A SECTION SIMILAR TO THIS WOULD BE NEEDED TO GET THE PERVIOUS CREDIT FROM THE CITY OF BROOKHAVEN

PERMEABLE PAVEMENT ON A TERRACED  
SUBGRADE WITH FULL EXILTRATION TO THE SOIL

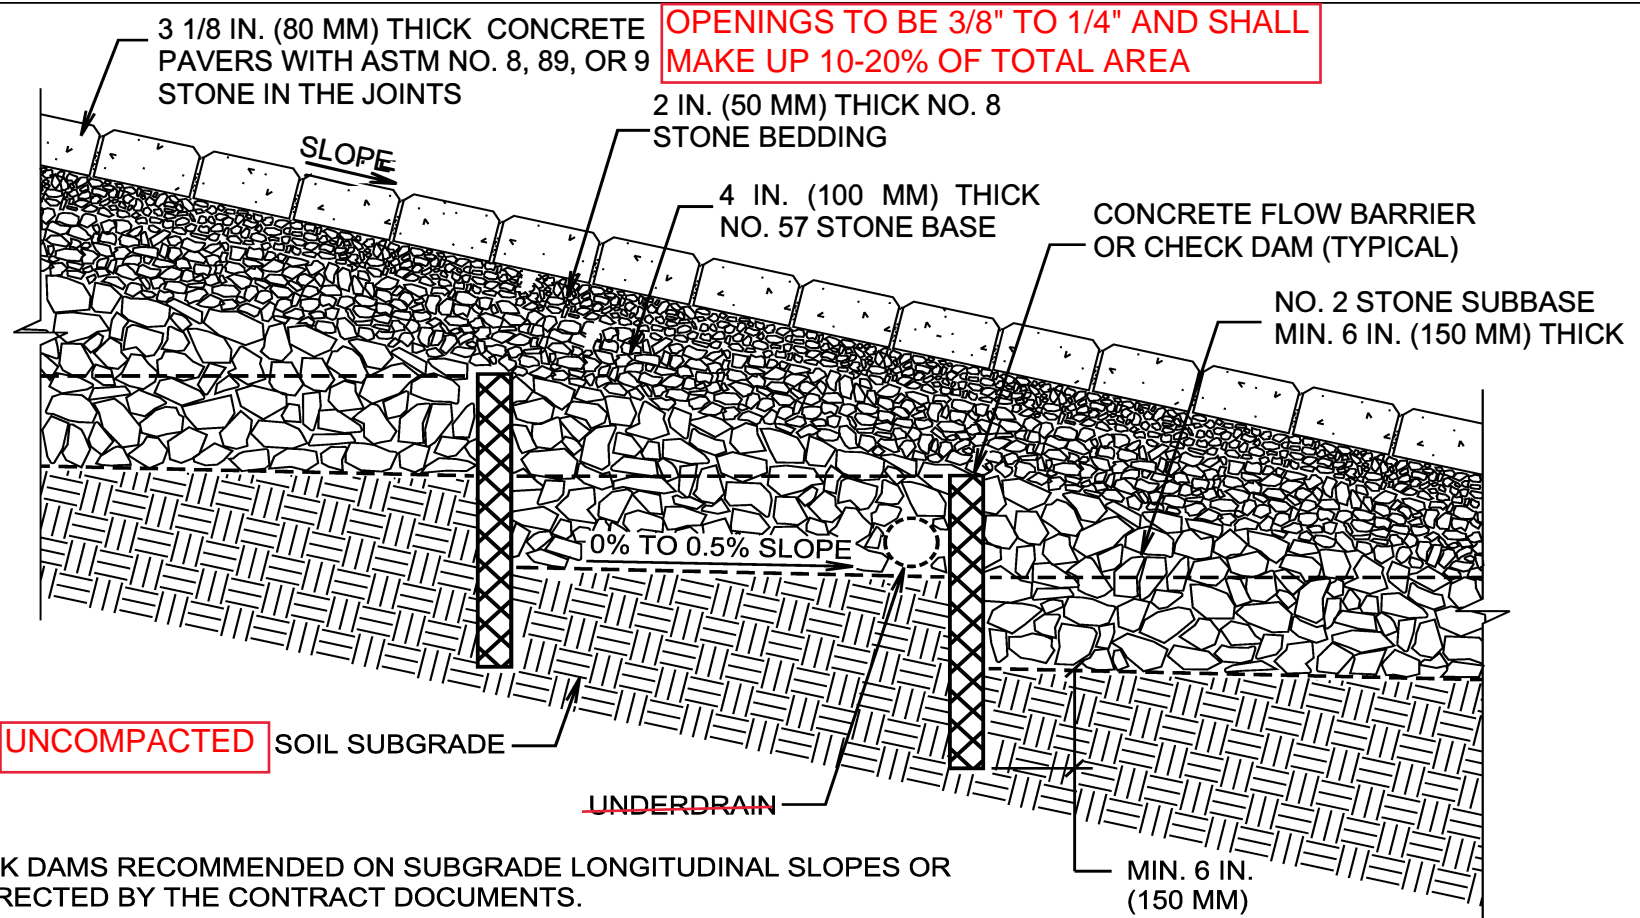
- 2. 6" of No. 2 Stone subbase is required to receive the 50% credit, 18" is required to receive 100% credit from the Brookhaven lot coverage requirements.
- 3. Nonwoven geotextile will be used on the top, sides & bottom of the subbase
- 4. No sand, gravel or fines allowed to get the pervious credit from the city of Brookhaven
- 4. If used, 12" of No. 2 Stone subbase is required below the underdrain to receive the 50% credit, 24" required to receive 100% credit from the Brookhaven lot coverage requirements.
